Report to the Future Melbourne (Planning) Committee

Agenda item 6.3

**Ministerial Planning Referral: TPM-2019-26
50-94 Waterfront Way and 2-16 Little Docklands Drive, Docklands**

15 September 2020

Figure 14 – DP Addendum Movement and Parking Plan 8 extract

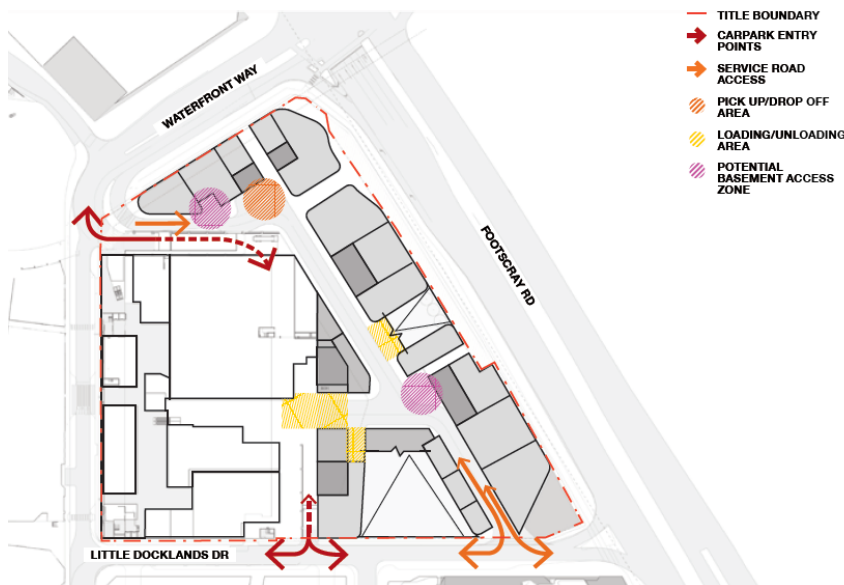
As illustrated in Figure 14 below, the proposed DP Addendum would replace the central road with a private vehicle thoroughfare for servicing and car park access for the development. This access is proposed to be largely decked over.

Figure 16 – DP Addendum maximum heights, roof plan

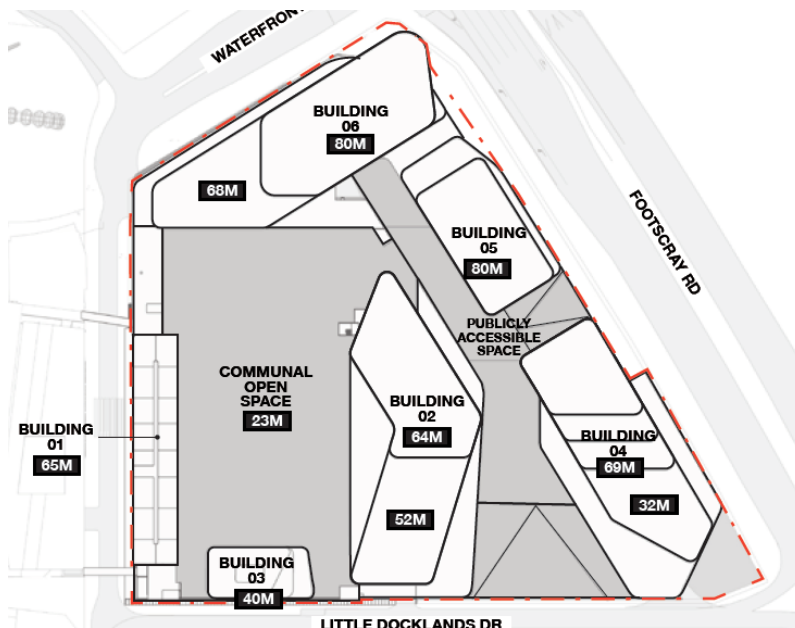
As illustrated in Figure 16 below, the proposed DP Addendum seeks discretionary maximum heights for each of the six building envelopes of between 40 and 80 metres. This represents an increase above the DDO54 controls of up to 35 metres.

Figure 17 – DP Addendum podium heights, tower setbacks and separation

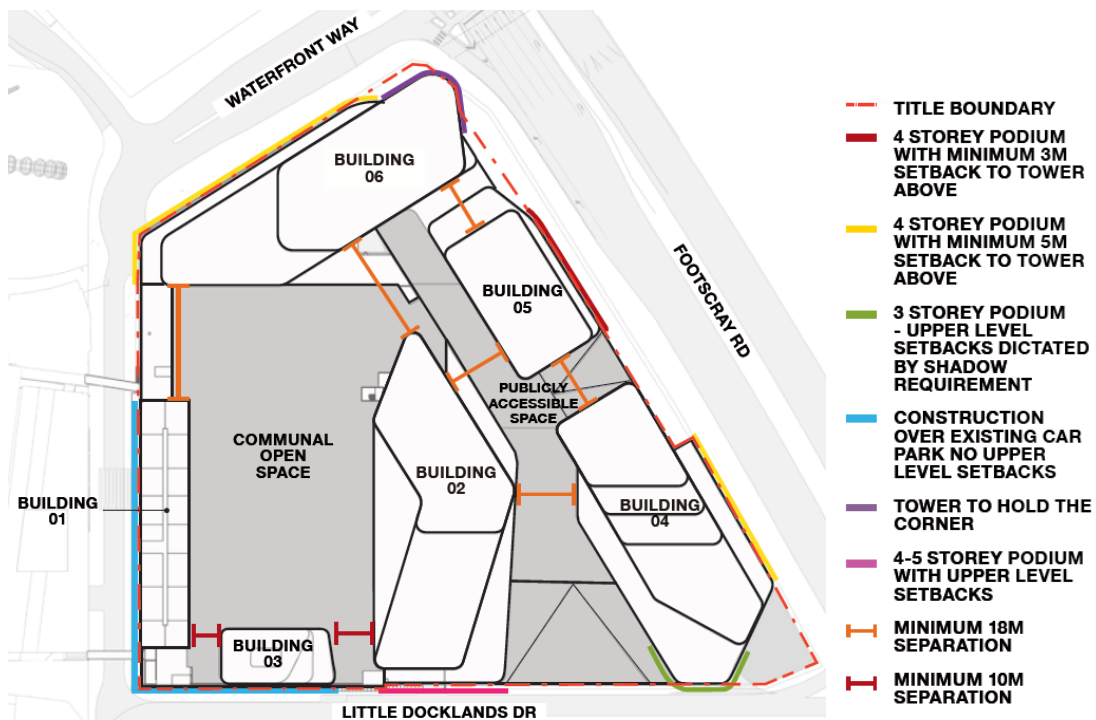
As illustrated in Figure 17 below, the proposed DP Addendum includes discretionary setback and building separation controls for each of the six building envelopes. In the main, the buildings would have a 3-5 storey podium with upper level setbacks of 3-5 metres. Exceptions to this include a 65 metre street wall height for Building 1, an 80 metre street wall for a portion of Building 6, and overshadowing controls guiding the southern setback of Building 4.

Figure 19 – DP Addendum staging diagram

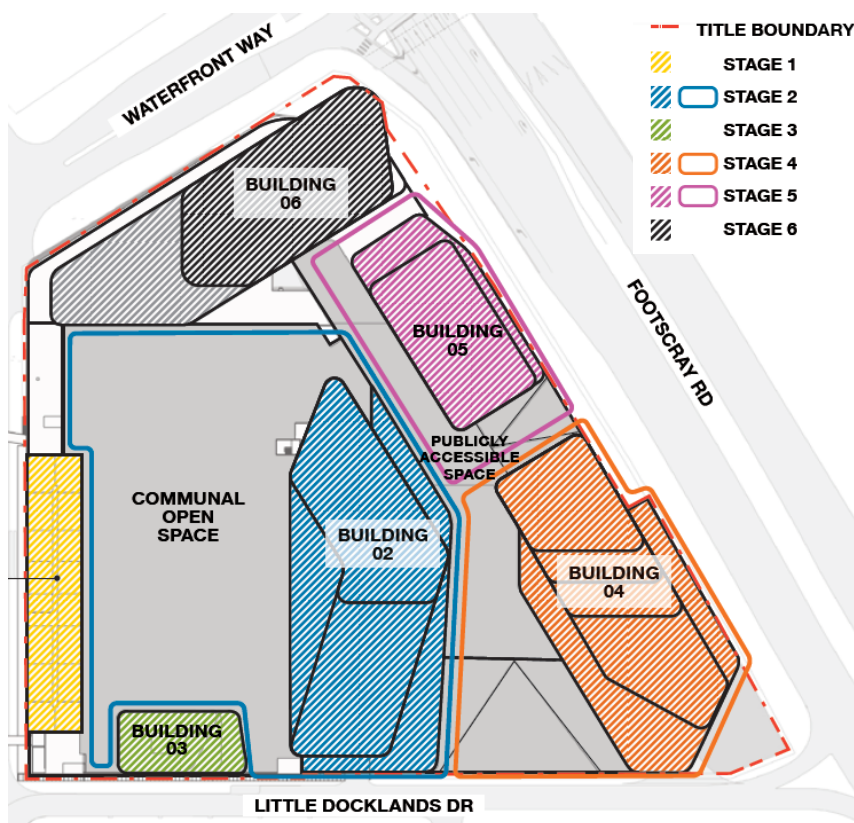
As illustrated in Figure 18 below, the proposed DP Addendum splits the site into six separate stages. A set of Staging Design Principles would provide guidance in relation to hoarding design, the treatment of blank walls and wind mitigation.

A review of this staging plan indicates that the majority of the elevated pedestrian link would not be delivered until the completion of stage 4 and would not connect through to Waterfront Way until the completion of the final stage.

Figure 25 – Future Building Plan from DP Addendum

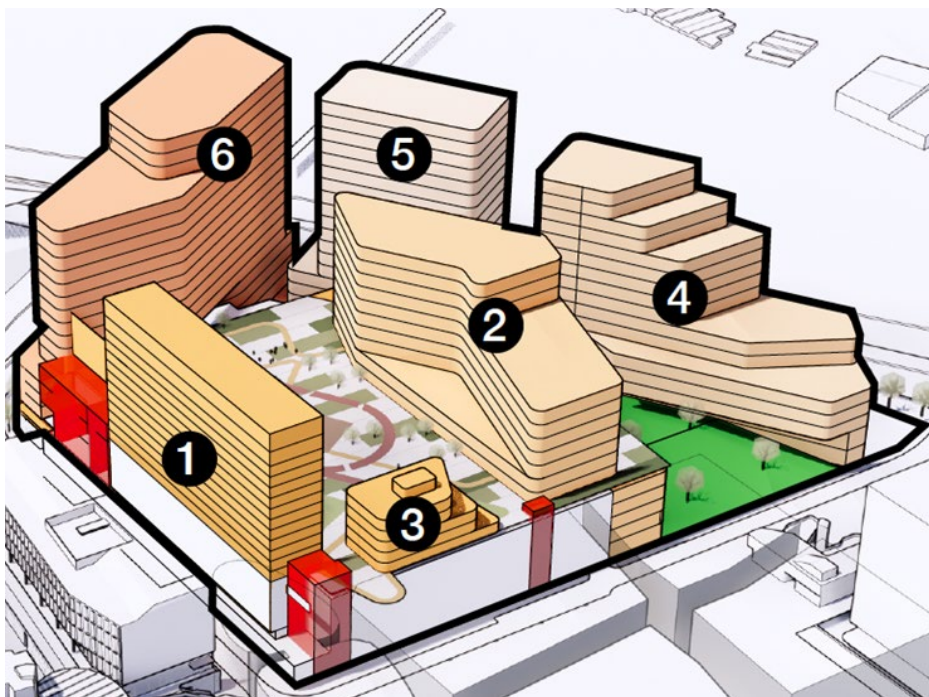
In terms of overshadowing, key buildings were stepped to reduce heights closer to Docklands Primary School on the southern side of Little Docklands Drive (refer to Figure 25). Subsequently, and due to continued reservations concerning building heights, Building 1 was reduced from 70 to 65 metres in height.

Figure 26 – Concept Plan 7 - podium heights, tower setbacks and separation

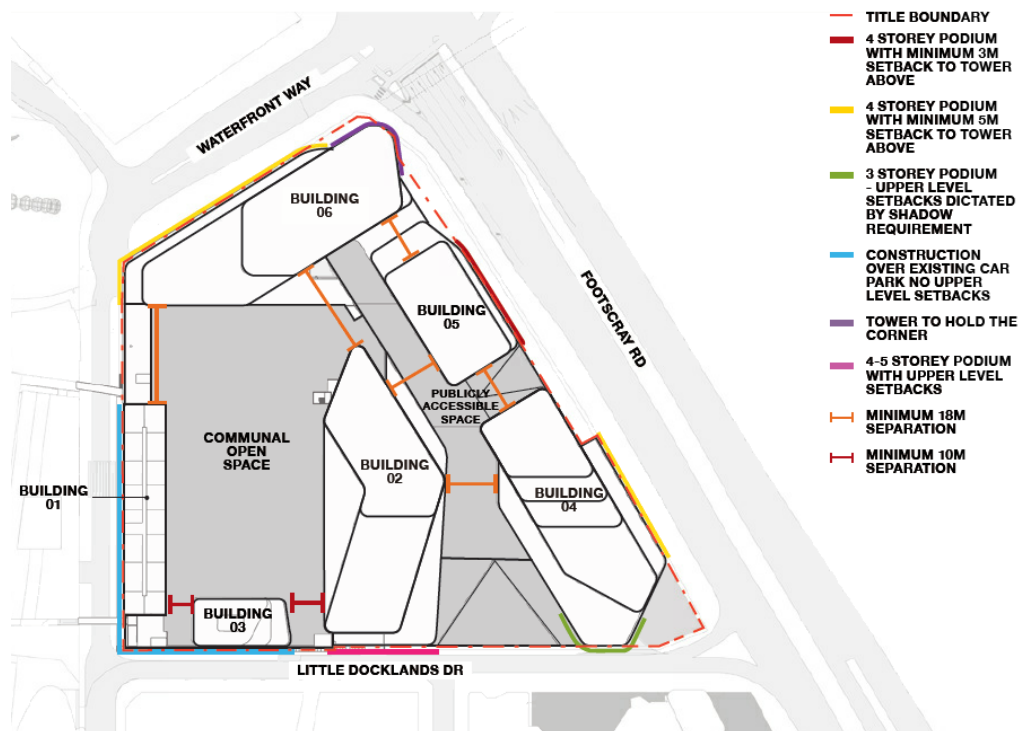
Setbacks to the internal publicly accessible spaces are also limited in the DP Addendum graphic (refer to Figure 26) with many at zero metres, and although some stepped forms are shown, these are indicative without any measurements to confirm them. In general terms, the DP Addendum graphics indicate quite specific forms which may be misleading as there are no measurable controls to support them.

Experience elsewhere, including the Hoddle Grid and Southbank, where setbacks were subject to close scrutiny in the formulation of Planning Scheme Amendment C270 and its associated DDO10 is that a mandatory minimum setback to provide both a visual break and to deflect wind down draughts is 5 metres (noting that the preferred setback remains at a more generous 10 metres). There is no good reason to differ from this practice at Waterfront City East, particularly given the exposed nature of the site.

Figure 27 – Concept Plans 4 & 5 – Public Realm Activation Ground and Level 1

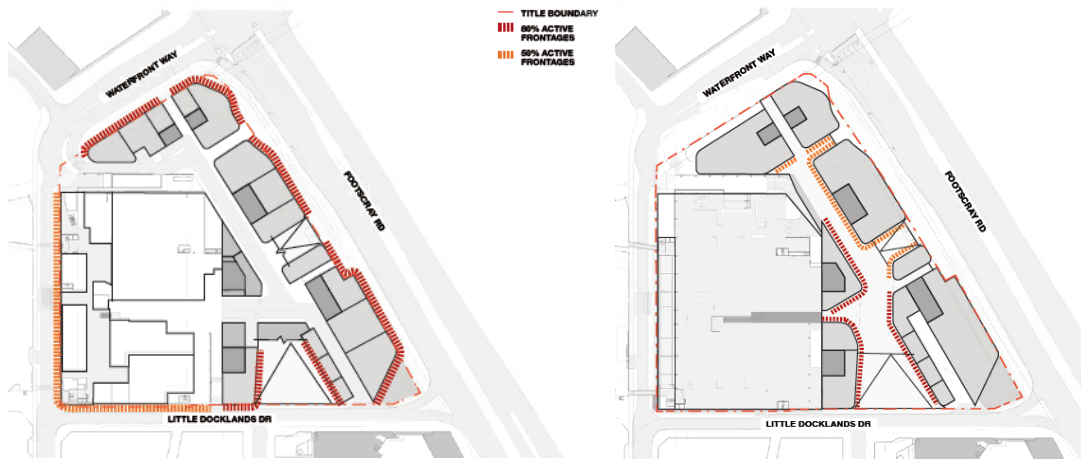
The Development Plan proposes surrounding street frontage activation of 80% to the refurbished car park and 50% to the rest at ground level (except in the Waterfront Lane undercroft), with a combination of 50% and 80% activation at the raised Level 1 public realm (refer to Figure 27). The upper levels, including around the car park roof, are described as having “passive surveillance” from surrounding uses.

What is not clarified, especially at Level 1, is the timing of such activation, with the lack of meaningful pedestrian traffic, no passing vehicle access and the closure of surrounding office related uses in the evening and on the weekend creating a dead zone likely to require gating out of business hours for security reasons. This is an unacceptable outcome.

Figure 30 – Massing Diagram depicting extent of floor area reduction to eliminate overshadowing to Docklands Primary School on the winter solstice

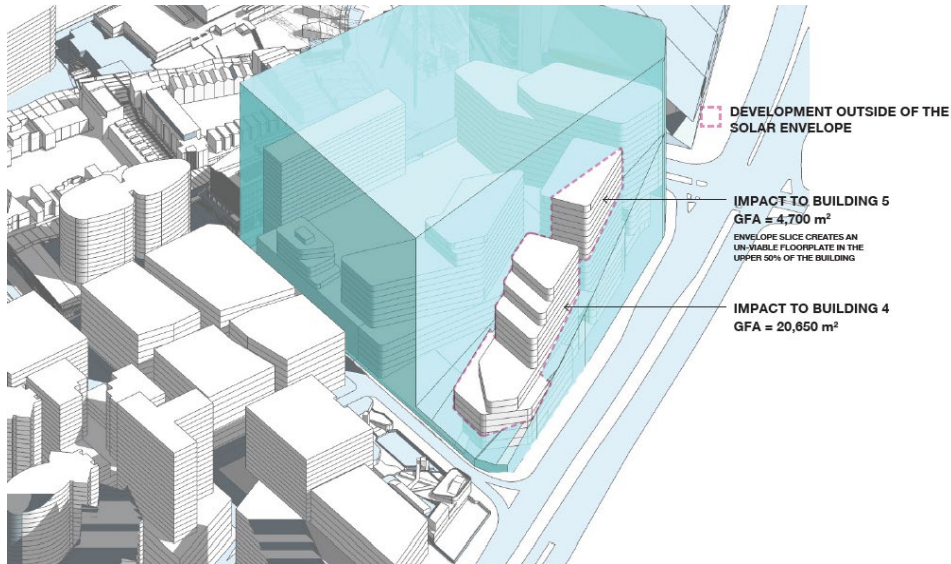
As illustrated in Figure 30 below, achievement of this would require a substantial (approximately 25,000m² GFA) reduction in floor area. Importantly, the existing DDO54 height limit of 50 metres, which applies to the southern portion of the site, would extensively overshadow the school at this time and the proposed control improves this to some extent.

In recognition of the importance of solar access to the outdoor areas of the Docklands Primary School, this design requirement should be mandatory.

Figure 31 – Proposed wind standards from DP Addendum

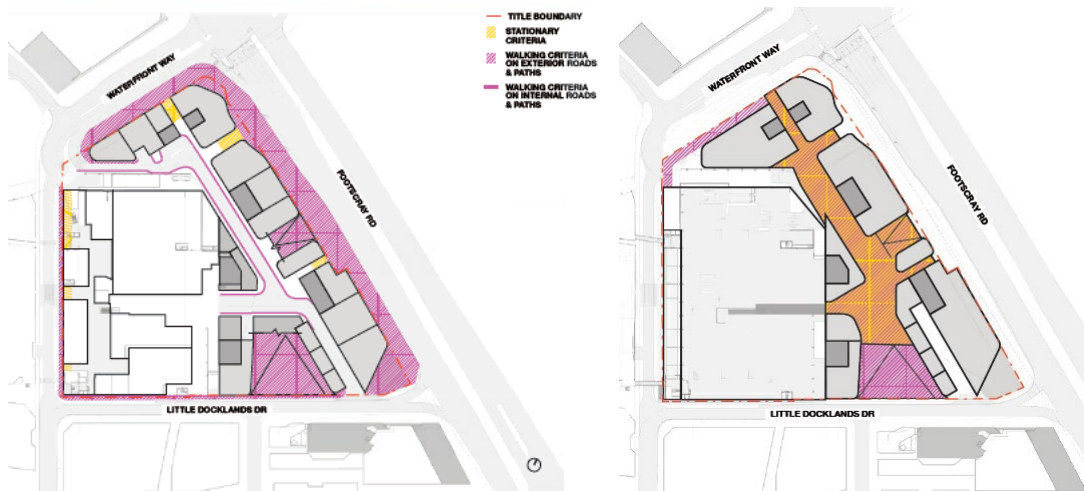
Wind impacts on this exposed Docklands site present major issues and need to be considered early in the development process. That is, it is not sufficient to establish guidelines or standards to be managed through design development at a later date because the fundamental built form parameters of allowable height and setbacks substantially determine wind impacts. The DP Addendum indicates areas where certain levels of wind comfort are required (refer to Figure 31), noting that these mandate no more than walking comfort in any area. A recent addendum to the wind report was required to extend the wind assessment area beyond the limits of the subject site to include the school and other adjoining areas.

Figure 34 – Level 1 pedestrian access from DP Addendum Movement & Parking Plan 4

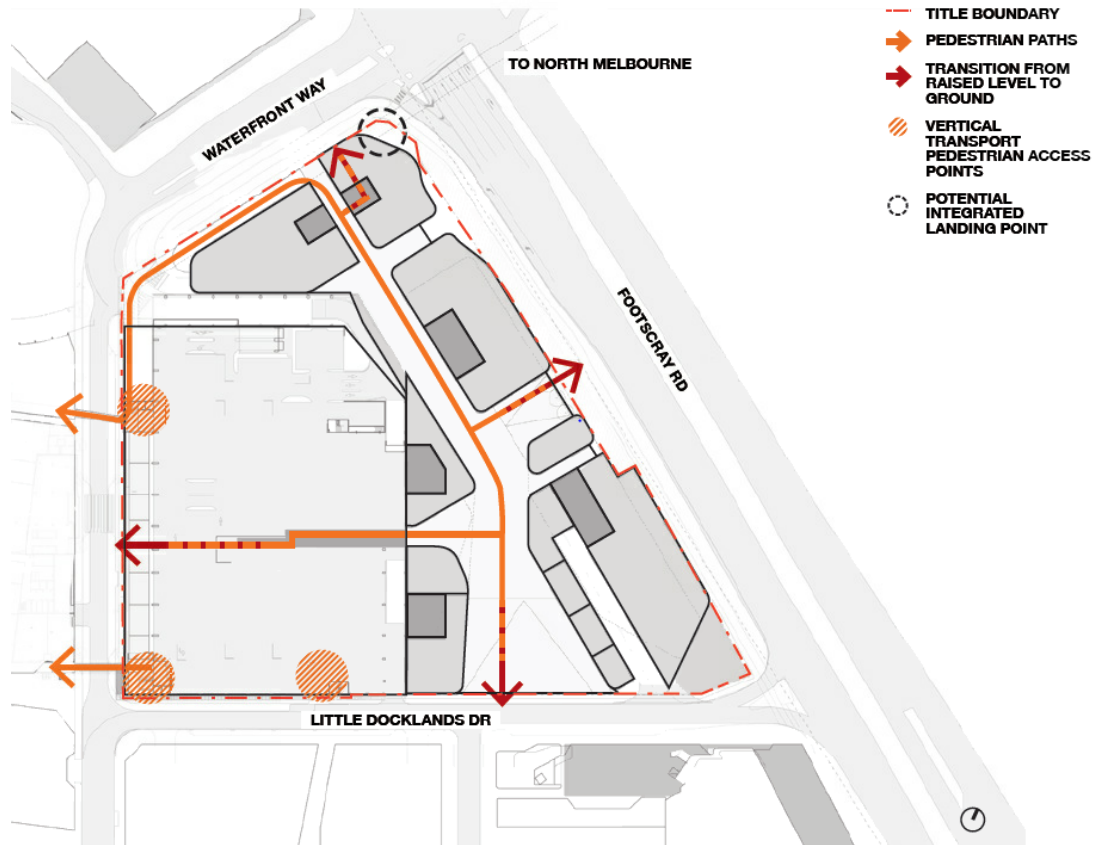
Due to the proposed undercroft and service road nature of Waterfront Lane which divides the site, there are no pedestrian connections through the site at ground level, but rather a series of pedestrian entry points to all buildings from the surrounding streets, including Footscray Road. Pedestrian movement through the site is proposed to occur exclusively at the upper level, mostly Level 1 (refer to Figure 34).

While in the future the raised level may link well to a possible bridge over Footscray Road to E-Gate and North Melbourne Station (as recommended in the *Draft West Melbourne Structure Plan*) there is currently no commitment to this infrastructure. The raised public realm therefore requires a significant level change of over 5 metres for all other movements with back-and-forth ramping in the southern open space, a travelator in the car park building and stairs and lifts in other locations (refer to Figure 35). This presents a severe handicap to casual access and activation, particularly when the surrounding uses are mostly offices with more direct access from undercroft parking and from the surrounding public streets.

Figure 36 – Vehicle access according to DP Addendum Movement & Parking Plan 8

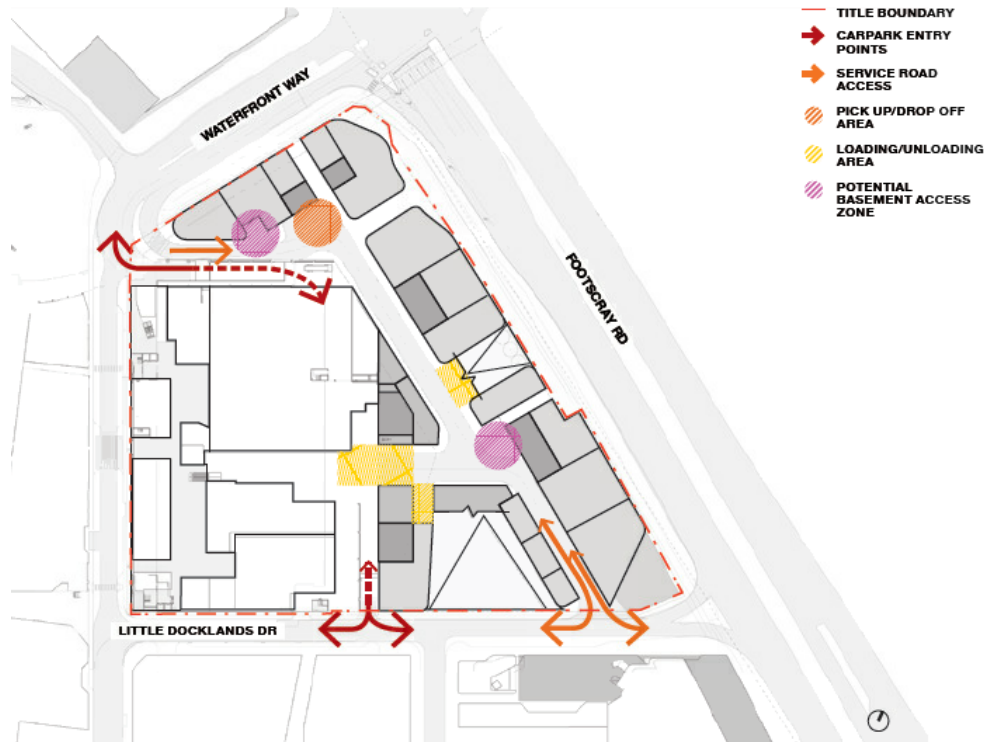
As discussed above, the proposed vehicle access is segregated in an undercroft level utilising a reconfigured Waterfront Lane as the main service spine with additional car park entry directly off Little Docklands Drive (refer to Figure 36). While this may simplify servicing, it relegates pedestrian movement to the raised upper level as discussed above (refer to section 7.4.1 of this report), being a fundamental aspect of the proposal which is not supported.

Figure 37 – Proposed staging from the DP Addendum

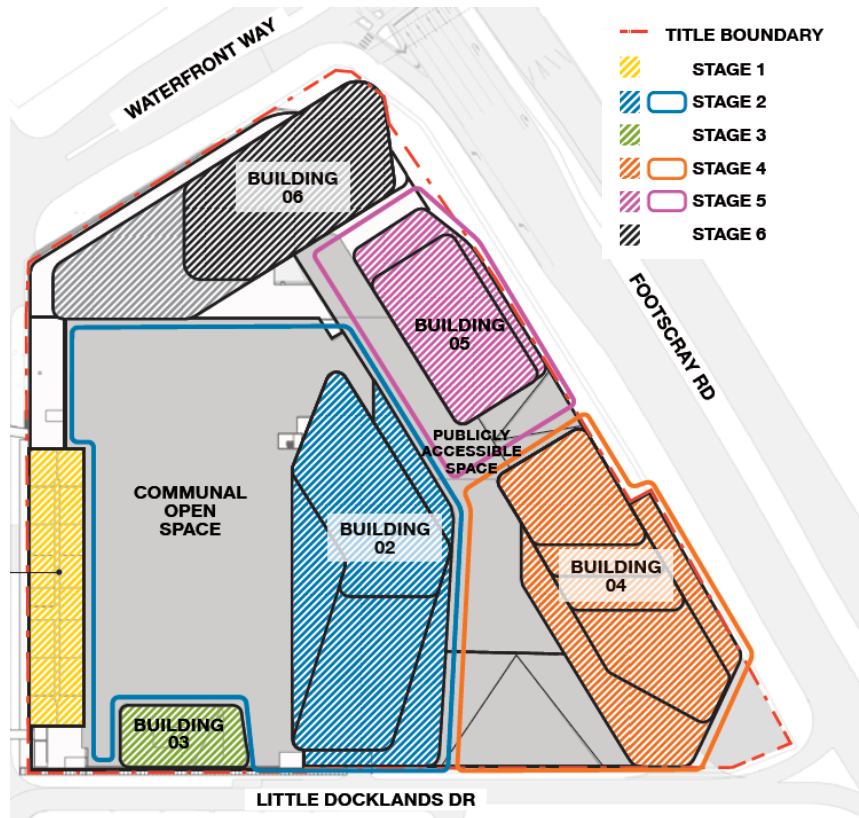
The staging diagram shown in the DP Addendum (refer to Figure 37) starts by developing Buildings 1, 2 and 3 over and around the existing car park, without constructing Waterfront Lane nor the raised deck above. Buildings 4, 5 and 6 then follow in order such that the common infrastructure will not be concluded until the whole development finishes.
